Manitoba Hydro

Pointe du Bois Spillway Replacement

Alteration

August 2012

Figure:
3.1
Rev 1

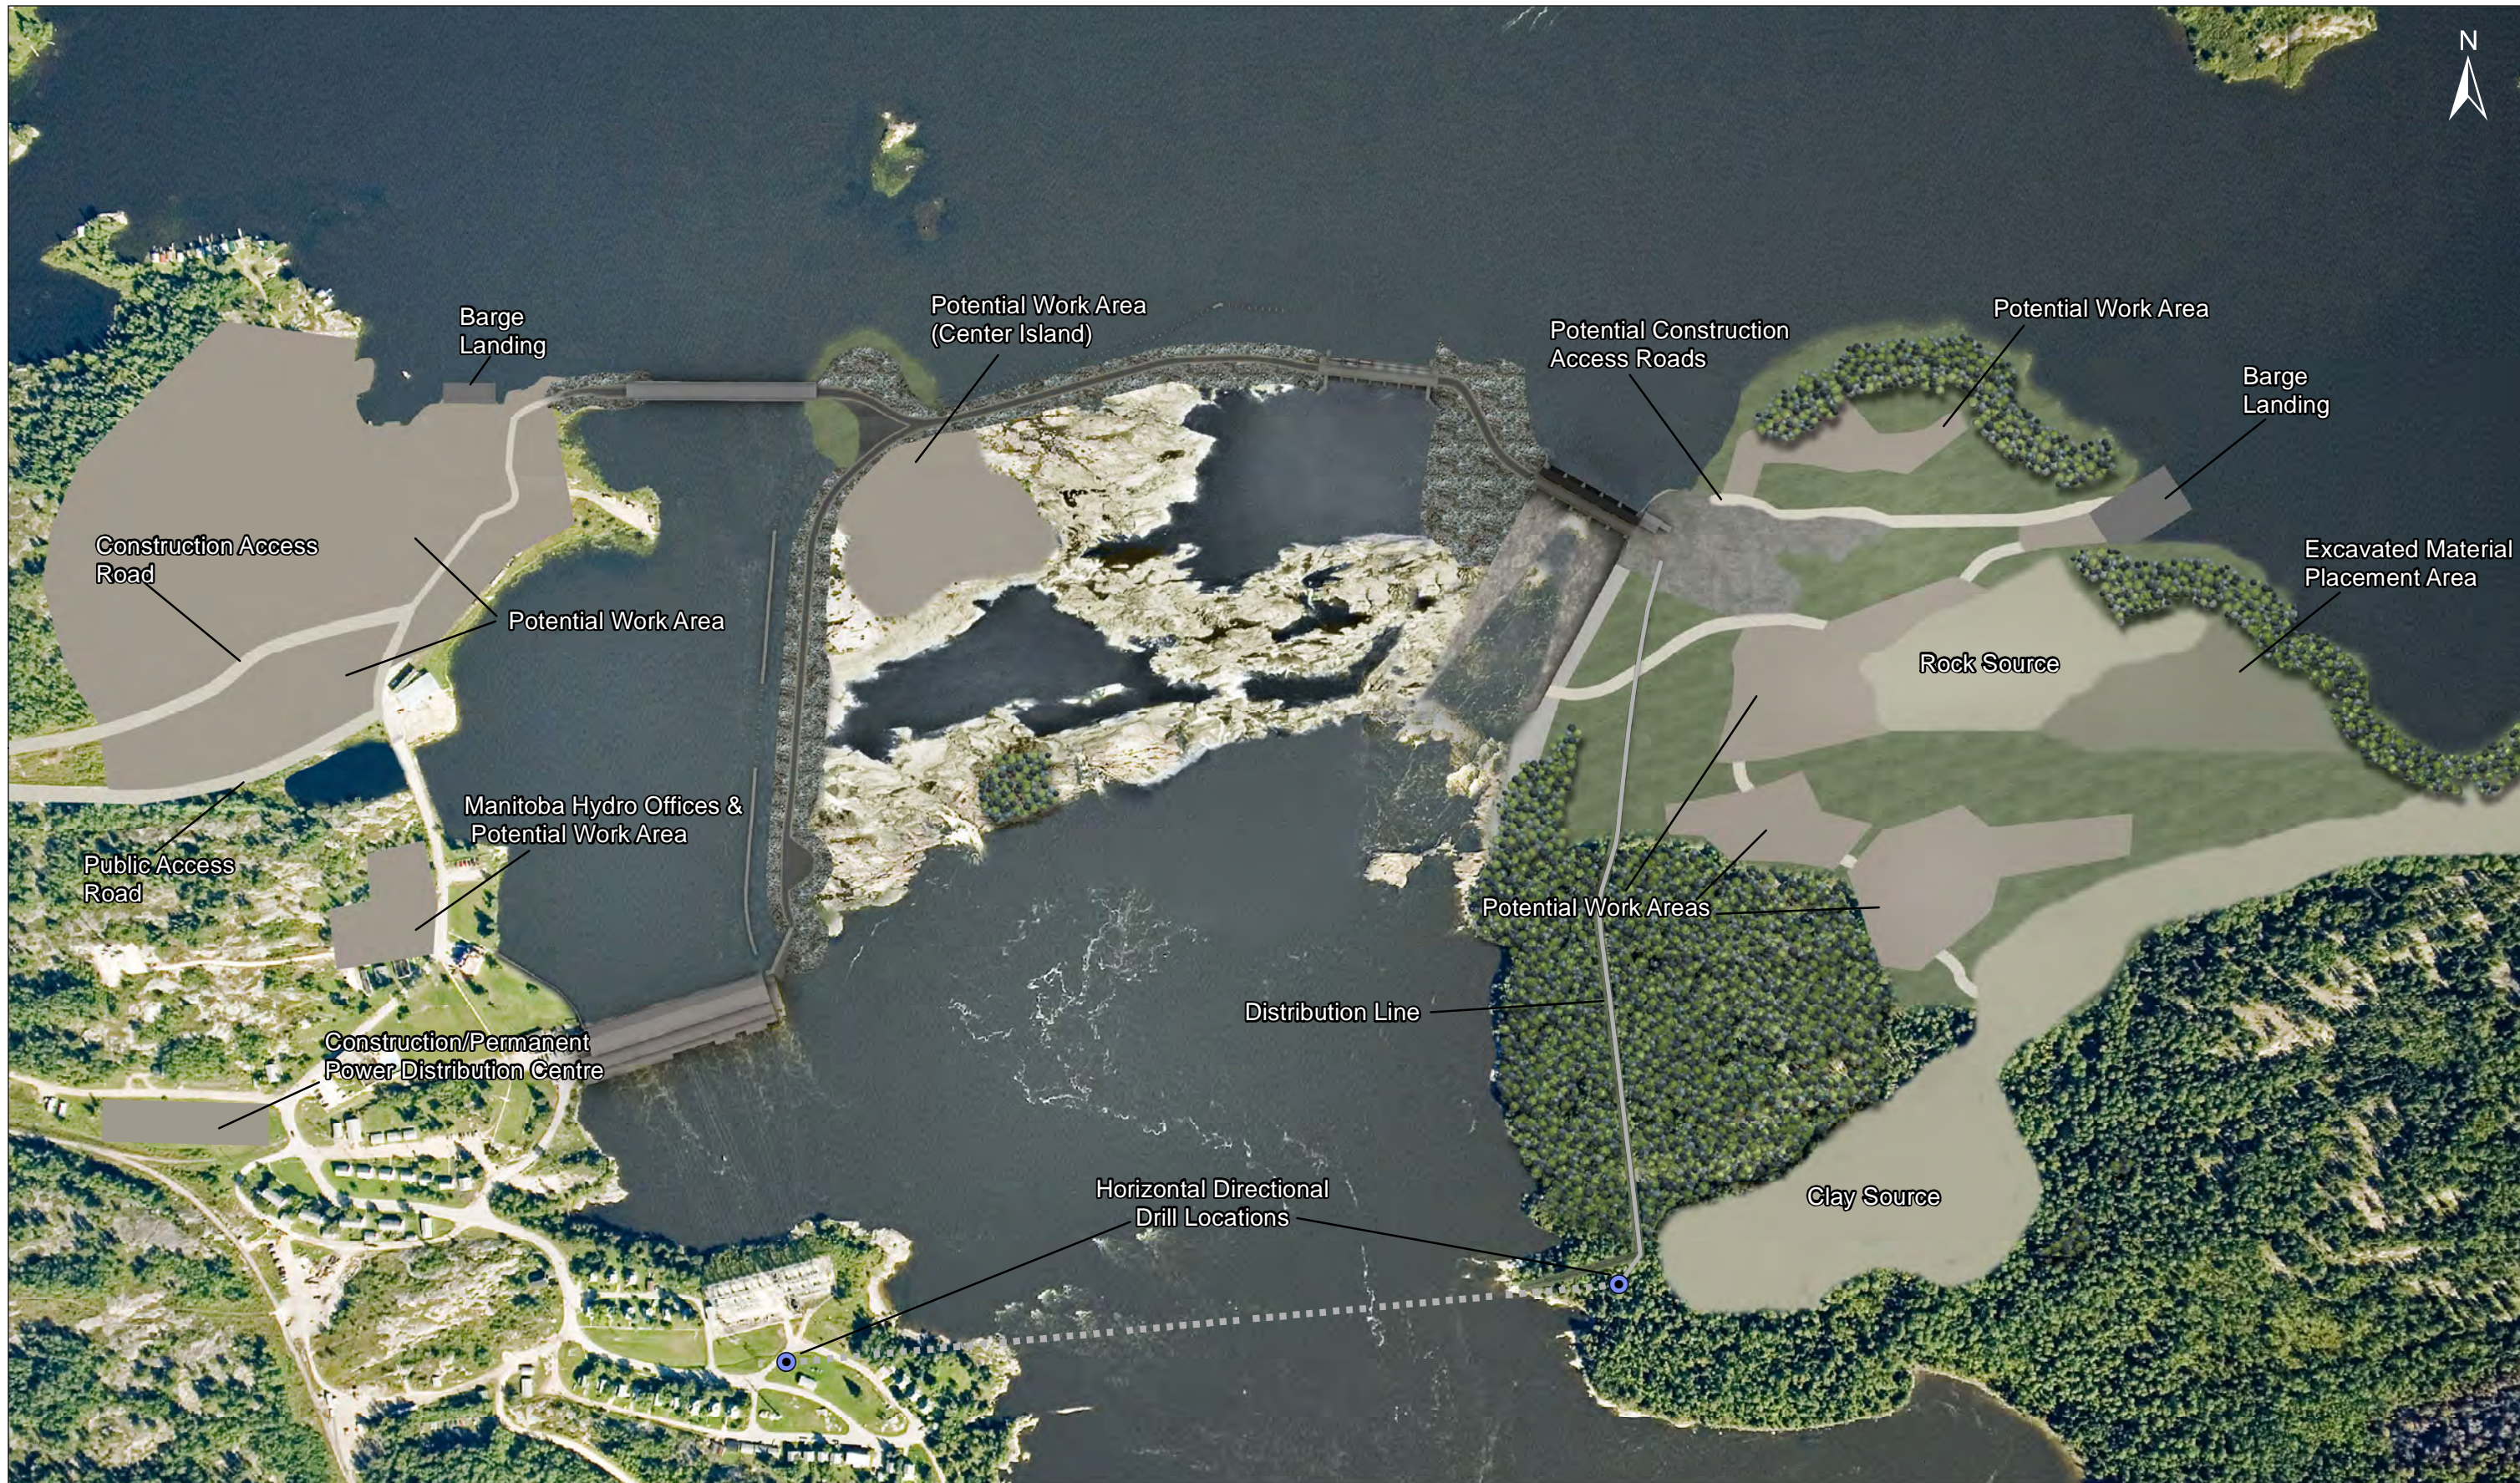
Figure 3.1 Rev1 outlines the existing, Original and Revised Arrangements.

To highlight the changes between both arrangements figures used in the June 2011 EIS that have been revised are labeled Rev1 (e.g. Figure 3.1 Rev1).

Figure:
3.5
Rev 1

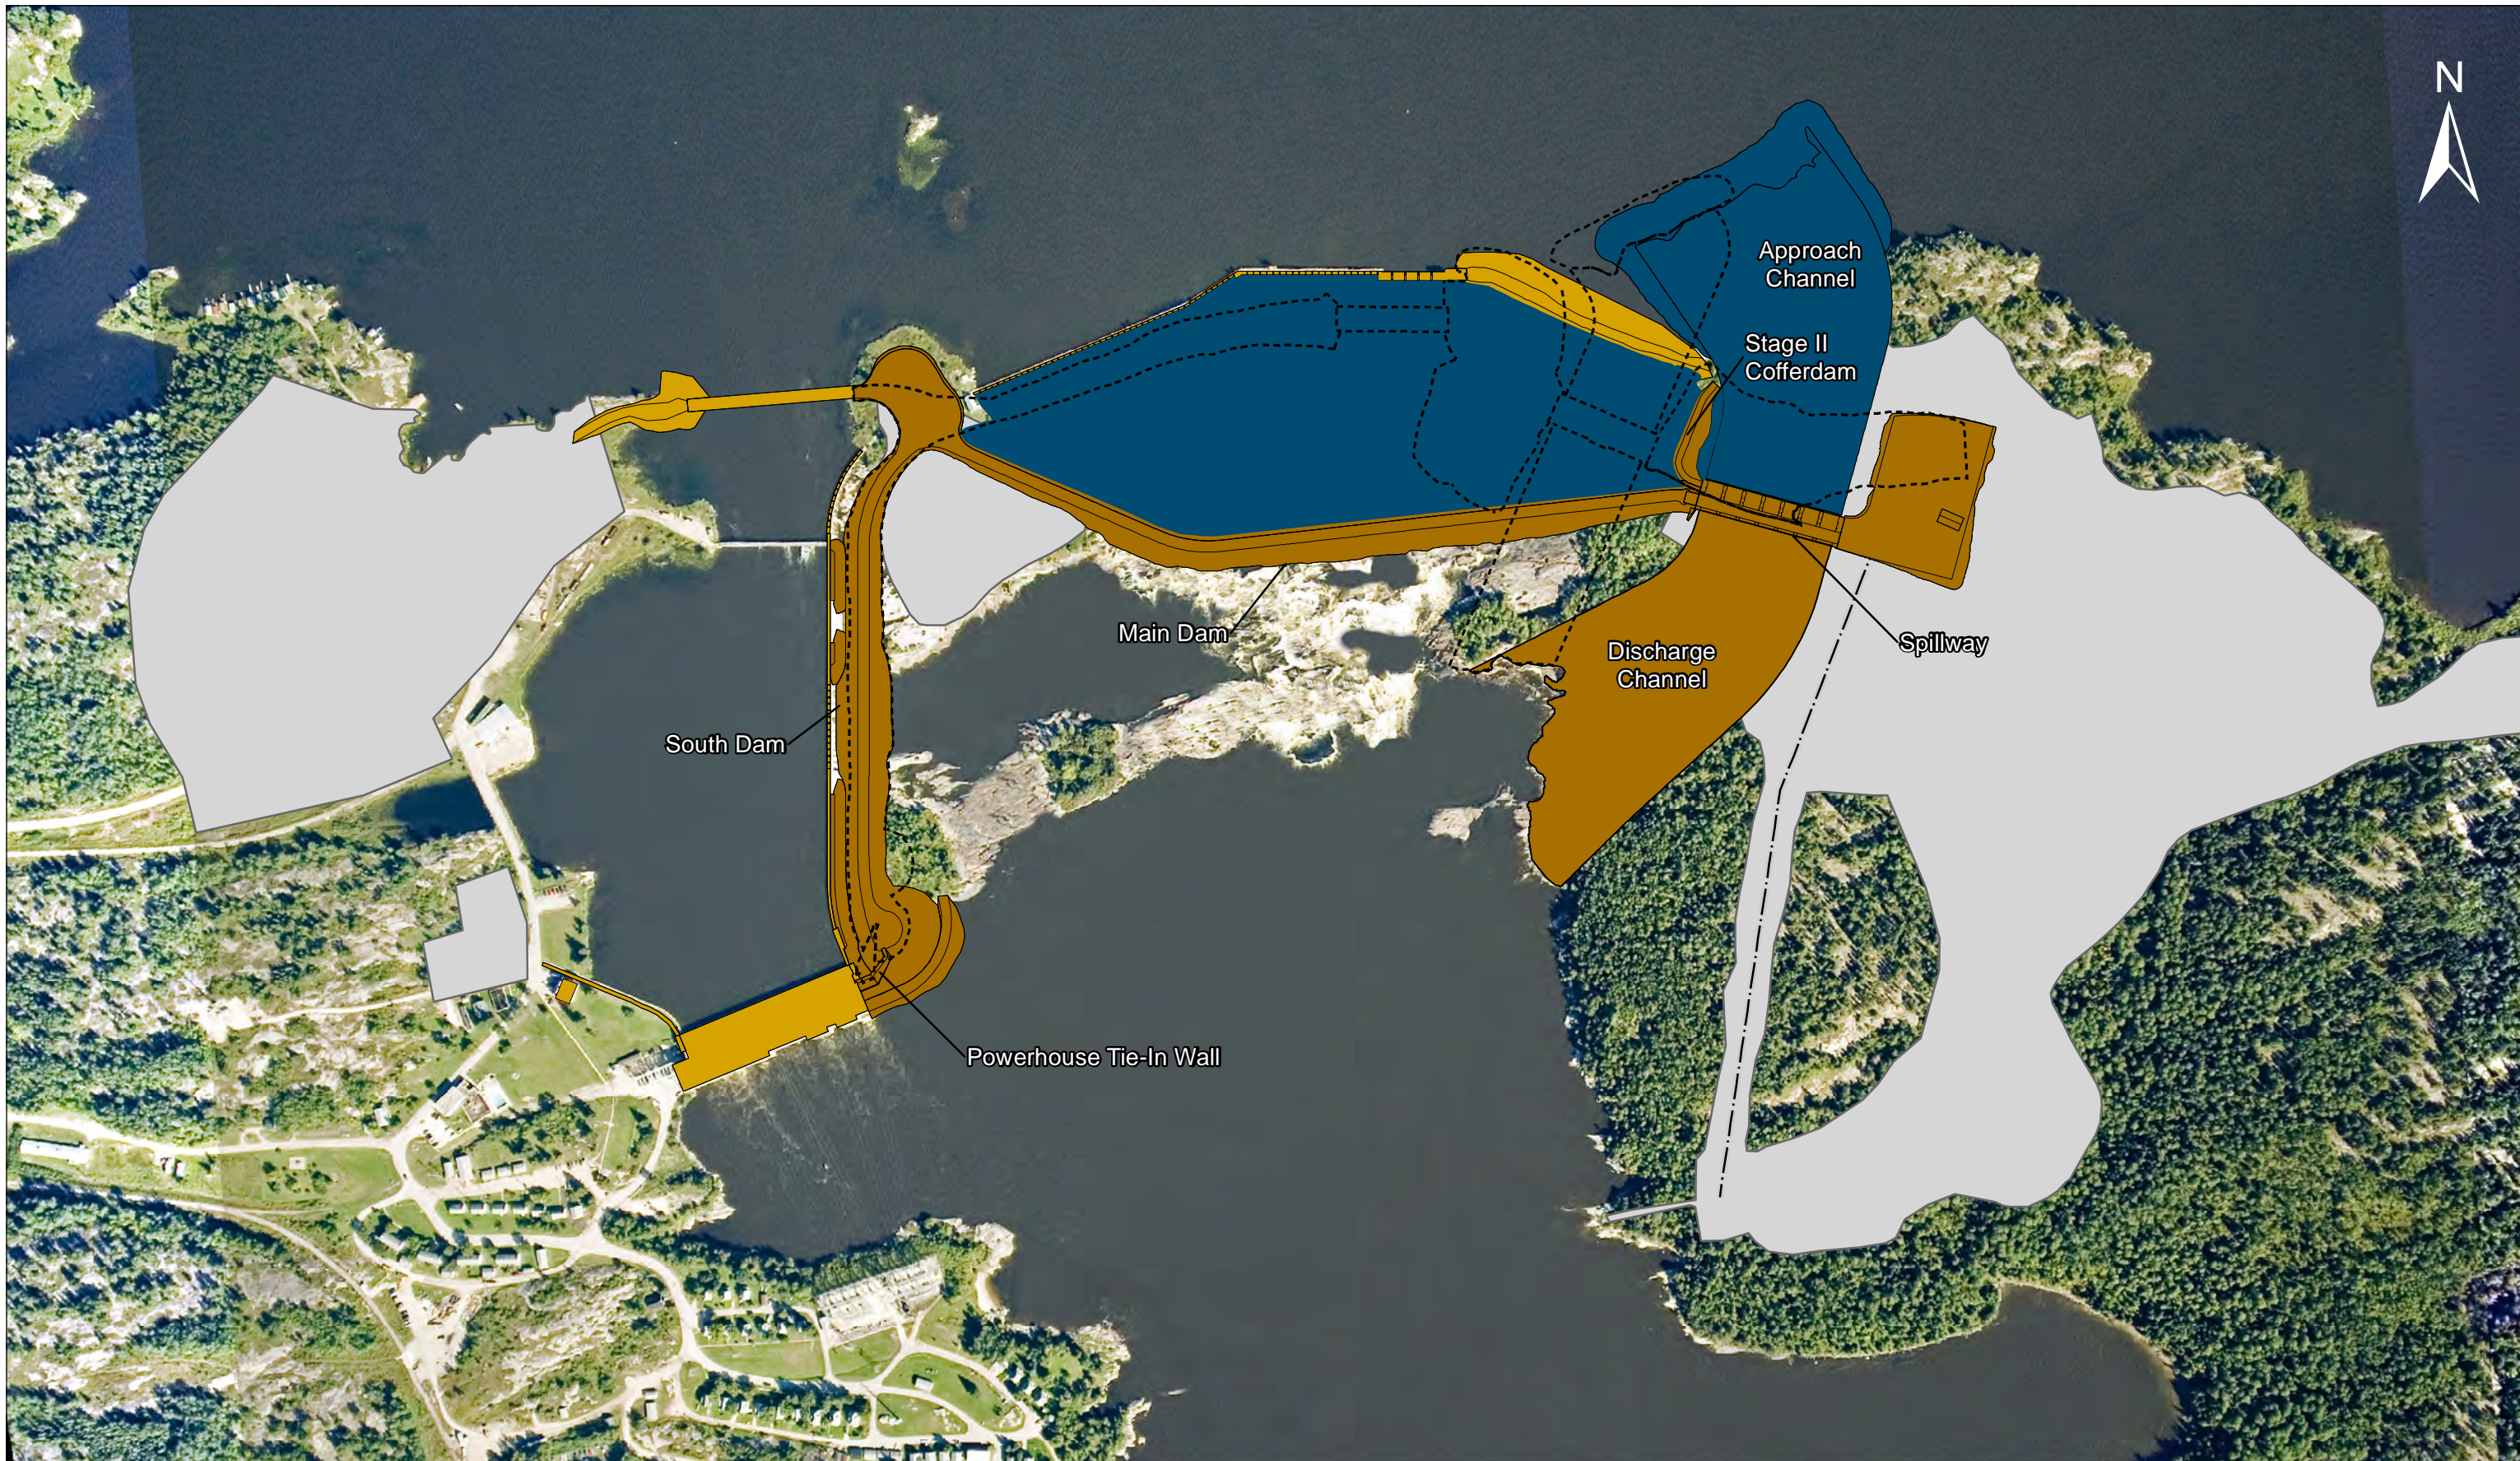
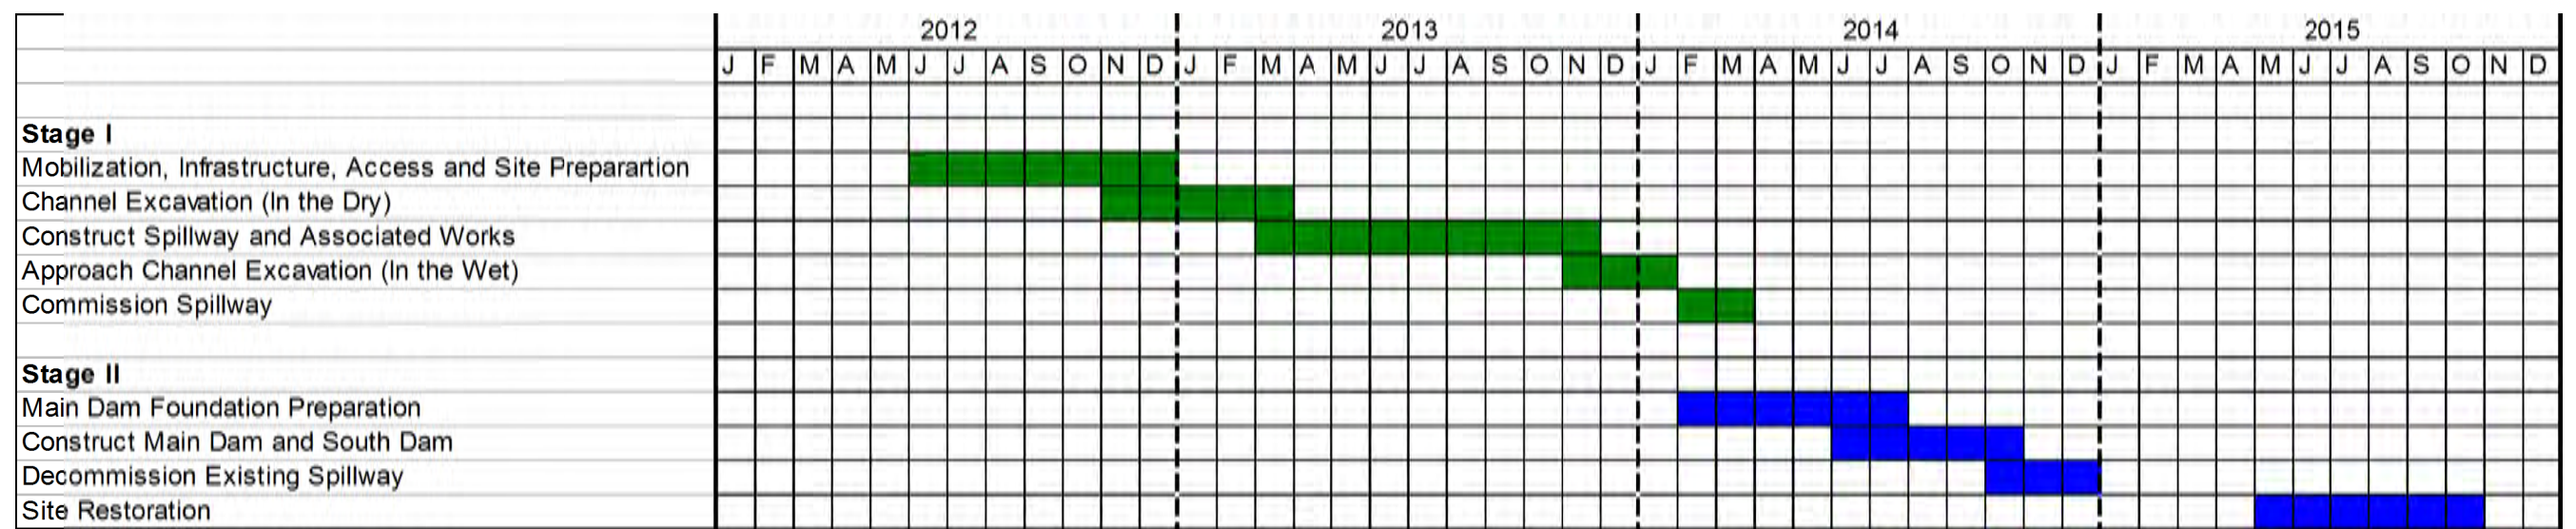
Supporting construction infrastructure and principal structures for the Original and Revised Arrangements are shown in Figures 3.4 and 3.5 and Figures 3.4 Rev1 and 3.5 Rev1, respectively.

The principal structures for the project include the following and are shown on Figure 3.5 Rev1:

- ◆ Spillway;
- ◆ Spillway approach and discharge channels;
- ◆ Earthfill dams (main dam and south dam); and
- ◆ Transition structures and wing walls.
